82545EM Gigabit Ethernet Controller Specification Update

June 6, 2006

The 82545EM Gigabit Ethernet Controller may contain design defects or errors known as errata that may cause the product to deviate from published specifications. Current characterized errata are documented in this Specification Update.

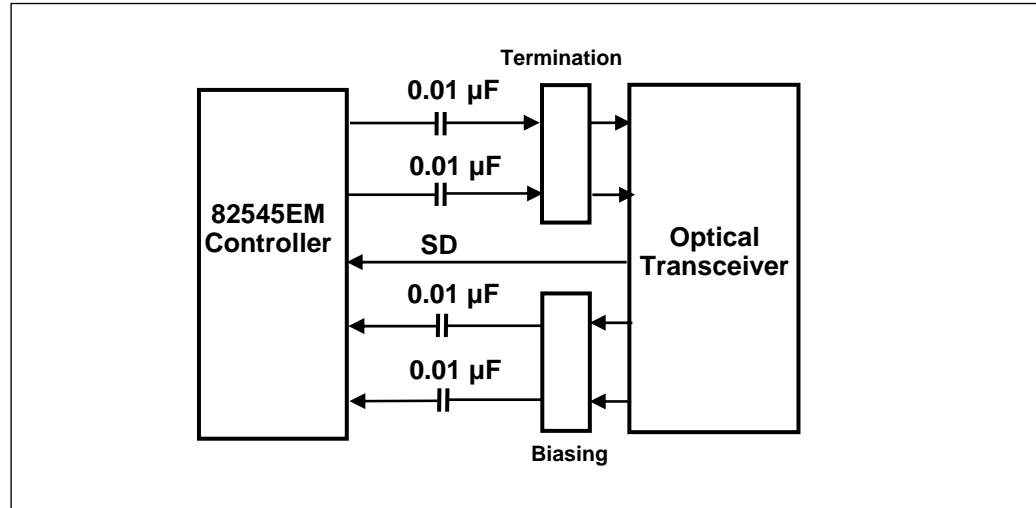
For the 82545EM Controller, the 0.5 revised schematic dated Sept. 24, 2001 is attached. This schematic did not change since the last Specification Update (0.6). Please note the following errors and omissions:

- The Gigabit Ethernet controller may be referred to as “Kenai 64”, “Anvik”, or “82546EB” on some of the sheets. The correct part reference is 82545EM.

- Some of the sheets refer to “Port 1.” Since the 82545EM controller is a single-port device, these references are irrelevant.
- The circuitry attached to the CTRL_15 pin requires modification for an erratum described elsewhere in this document.

- Ball A8 should be re-labeled as TEST# and have the pull-down resistor removed. This change is also described elsewhere in this document.

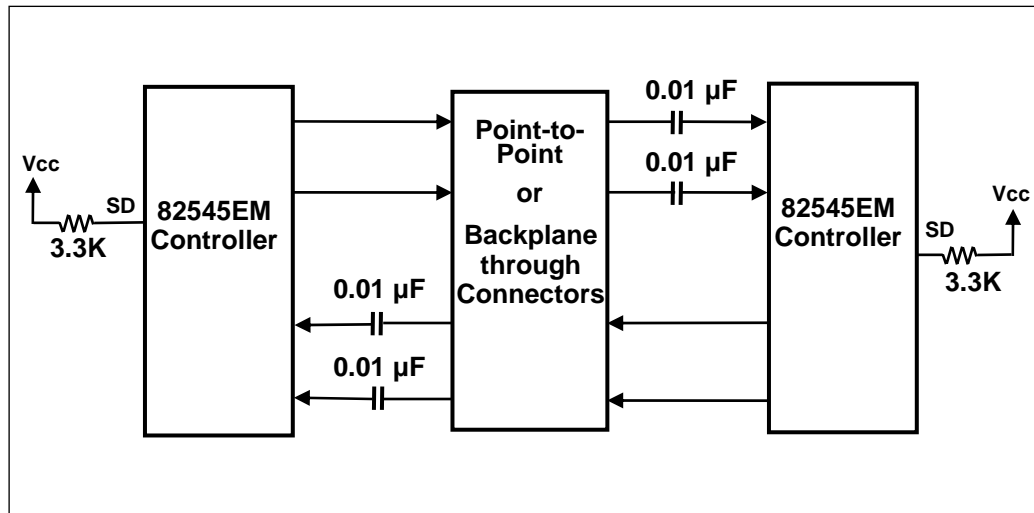
Problem: Intel added new SERDES functions to the 82545EM controller. SERDES stands for Serializer-Deserialzer and is a circuit that converts Ethernet packet data from a parallel TBI format to a 1.25 GHz bidirectional serial stream. For 1000BASE-SX or 1000BASE-LX fiber applications, SERDES integration typically saves the designer the expense and board space of a 64-lead external device. The 82545EM controller contains one SERDES. A '10' needs to be written in ICW3 bits 1 and 0, respectively, in order to enable this feature.

The datasheet for the 82545EM Controller will change to define pins as follows:

82545EM controller fiber-based applications will use the SERDES interface to drive a 1000BASE-SX or 1000BASE-LX optical transceiver as illustrated in the above figure. The 82545EM controller is internally terminated, so no external termination is required.

Alternatively, the 82545EM may be used in short haul gigabit backplane data applications without transceivers and optical fibers. No special termination is required because the 82545EM device is internally terminated. The figure below illustrates a gigabit backplane or point-to-point circuit based on either the 82545EM device:
